CTC MEETING # 22
December 1 – 2, 2011
CTC Elevator Lobby Study Group

TOPICS ADDRESSED BY PROPOSALS

SMOKE BARRIER CONTINUITY

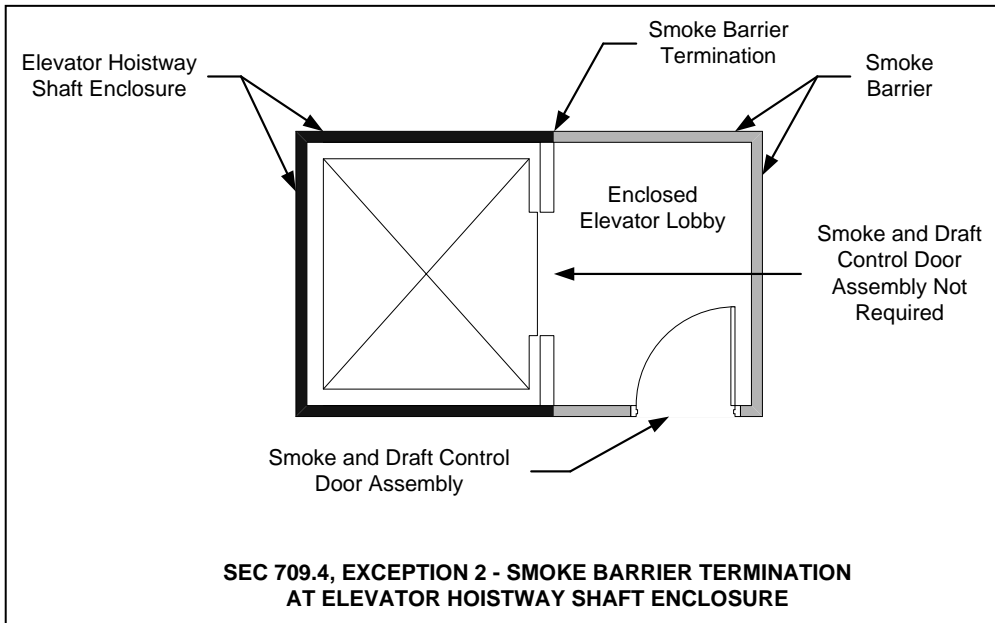
709.4 Continuity. *Smoke barriers* shall form an effective membrane continuous from outside wall to outside wall and from the top of the foundation or floor/ceiling assembly below to the underside of the floor or roof sheathing, deck or slab above, including continuity through concealed spaces, such as those found above suspended ceilings, and interstitial structural and mechanical spaces. The supporting construction shall be protected to afford the required *fire-resistance rating* of the wall or floor supported in buildings of other than Type IIB, IIIB or VB construction.

Reason: Provisions are necessary to clarify that opening protection at the hoistway opening is not necessary when an enclosed elevator lobby is provided in accordance with Section 405.4.3, 3007.7.2, or 3008.7.2. An enclosed elevator lobby protects the hoistway from smoke migration, therefore the hoistway is already protected. In addition the shaft walls provide sufficient smoke and draft protection to allow the smoke barriers to terminate at those walls.

CORRIDOR SMOKE AND DRAFT ASSEMBLY REQUIREMENTS

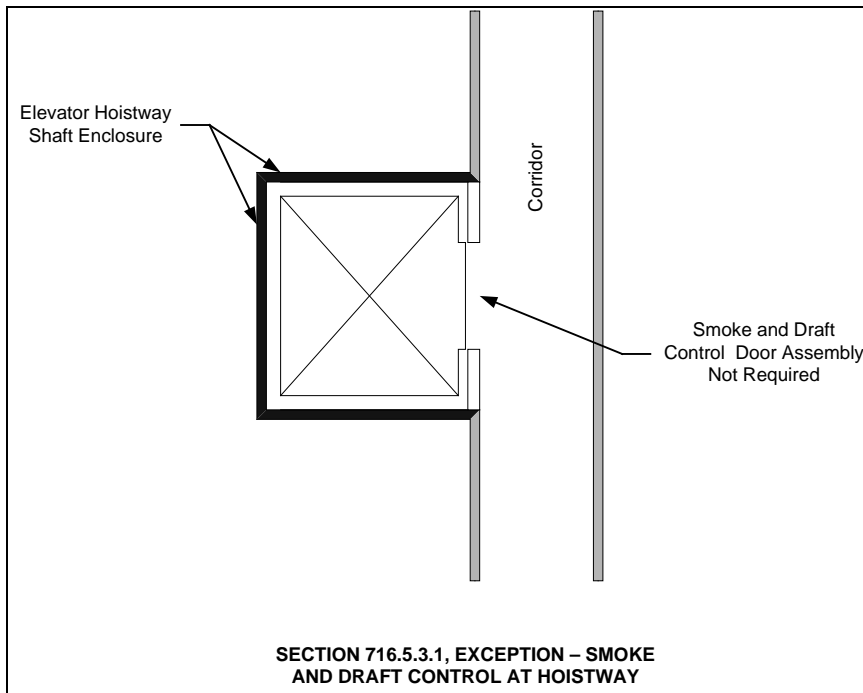
716.5.3.1 Smoke and draft control. *Fire door* assemblies shall also meet the requirements for a smoke and draft control door assembly tested in accordance with UL 1784. The air leakage rate of the door assembly shall not exceed 3.0 cubic feet per minute per square foot ($0.01524 \text{ m}^3/\text{s} \cdot \text{m}^2$) of door opening at 0.10 inch (24.9 Pa) of water for both the ambient temperature and elevated temperature tests. Louvers shall be prohibited. Installation of smoke doors shall be in accordance with NFPA 105.

Exception: Where enclosed elevator lobbies are not required by Section 713.14.1, elevator hoistway doors opening into a corridor are not required to meet the requirements for a smoke and draft control door assembly.

Reason: This proposal is intended to clarify that when an elevator lobby is not required in accordance with Section 713.14.1 that smoke and draft protection is not required when the hoistway opens into a rated corridor. See figure below. Section 713.14.1 is based upon number of stories and not the fact that such elevators open onto a rated corridor so it is not entirely clear how the code is currently written that this was the intent . The following are the sections that are relevant to this issue and which demonstrate how such confusion could occur. The lobby provisions are independent from the corridor provisions.
